IloT Product End-of-Life Notice

End of Life, Last Time Buy and Replacement Announcement

For immediately release, Advantech is announcing the End of Life (EOL) of **ADAM-4050-DE, ADAM-4053-AE, ADAM-4060-DE, ADAM-4017-D2E, ADAM-4017+-CE, ADAM-4018+-BE, ADAM-4019+-AE, ADAM-4021-DE**. The relative replacing models are as below list. Customers who had purchased this Part Number either to purchase any additional rules or migrate to the new replacement models if possible before the EOL’s shipment date.

Reason for the Change

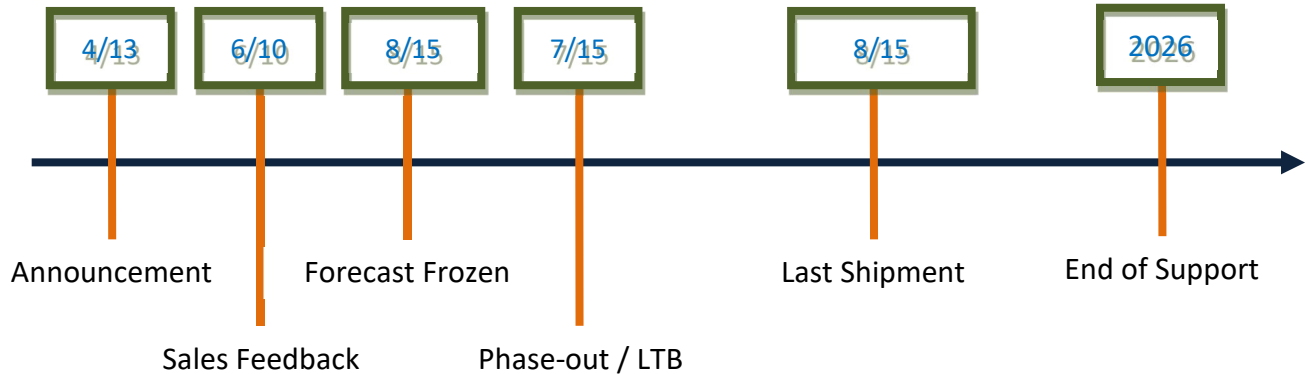
Key component SANKEN SAI01-V1 Power IC phased out(14S3010100)

New chip : TI TPS560430 Power IC(1410030748-01)

Upgrade to new MCU (TI MSP432P401R)

Impact	Old version	New version
Pin assignment	Forward compatible	
Hardware spec	Forward compatible (the only difference is power consumption) New function, support Modbus/RTU and FW download	
FW	New version, depends on each module	
Utility	Adam/Apax .NET Utility 2.6.00 B09 or later version
